Gold Line

BUS RAPID TRANSIT PROJECT • ENVIRONMENTAL ASSESSMENT (EA)
FINDING OF NO SIGNIFICANT IMPACT (FONSI)

ENVIRONMENTAL RE-EVALUATION

August 2020

FIGURE 2-34: 15% DESIGN I-494 PARK-AND-RIDE

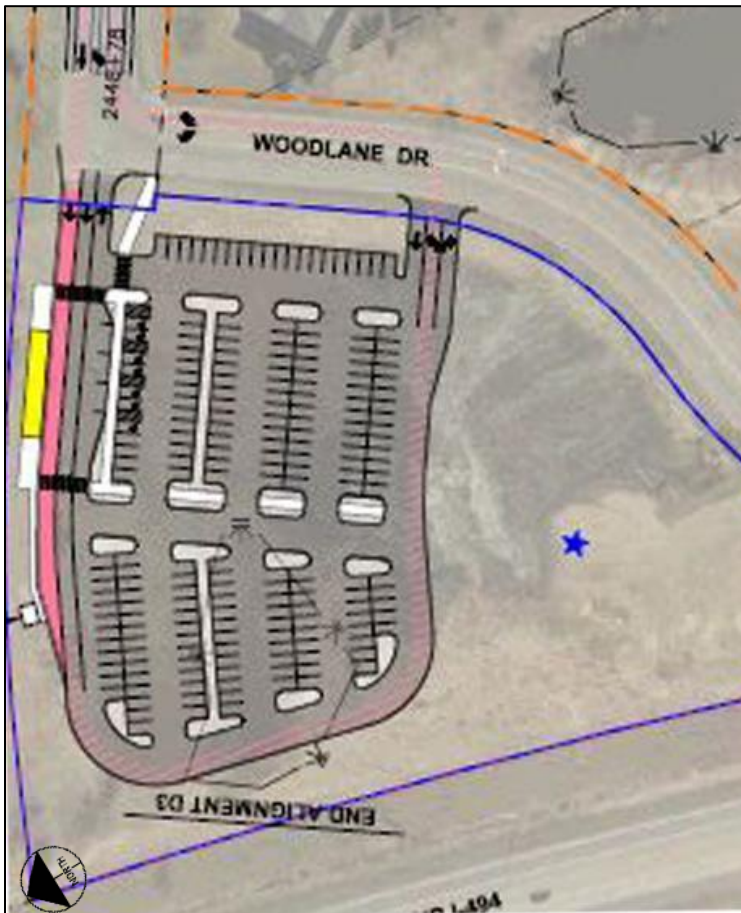
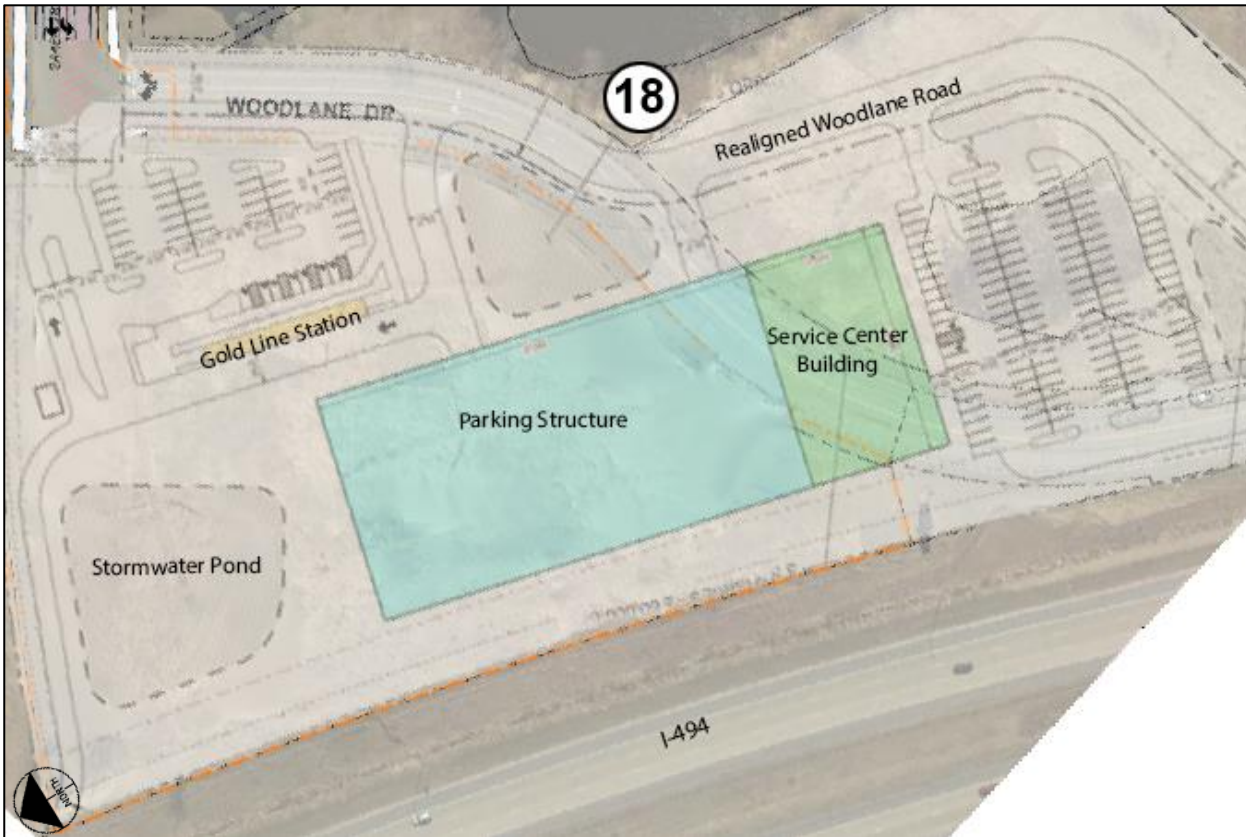
Table 2-18 summarizes impacts to resources potentially affected by the 30 percent design change to the Woodbury I-494 Park-and-Ride to include Joint Development. Figure 2-34 and Figure 2-35 show 15 percent design and 30 percent design, respectively.

The EA/FONSI proposed a new traffic signal at Bielenberg Drive/Guider Drive intersection to provide efficient movement of BRT buses onto Bielenberg Drive. The 30 percent design modifications maintain the traffic signal at the Bielenberg Drive/Guider Drive intersection. The Project would not result in a decline in level of service. The 30 percent design maintains the traffic signal at Bielenberg Drive/Guider Drive intersection. The added 312 parking spaces at the Woodbury I-494 Park-and-Ride and the JD opportunity would not change the traffic operations reported in the EA/FONSI for most intersections. The analysis showed that all intersections would operate at

The EA/FONSI identified a 5.5-acre partial acquisition of private property north of Woodlane Drive. The JD opportunity site plan will acquire the entire 8.7-acre parcel on both sides of Woodlane Drive and realign Woodlane Drive to accommodate site development.

The EA/FONSI reports Alignment D3 would add or reconstruct 29 acres of impervious surface, which would require volume and rate control to use existing storm sewer systems. A BMP was proposed at the 200-space park-and-ride. The JD opportunity site increases impervious area by 3.2 acres, requiring additional BMPs on the site to manage increased stormwater volume and rate. The Council is continuing coordination with the City of Woodbury to determine if additional on-site BMPs will be constructed or mitigation should involve expanding nearby existing stormwater ponds that serve both the JD site as well as surrounding development.
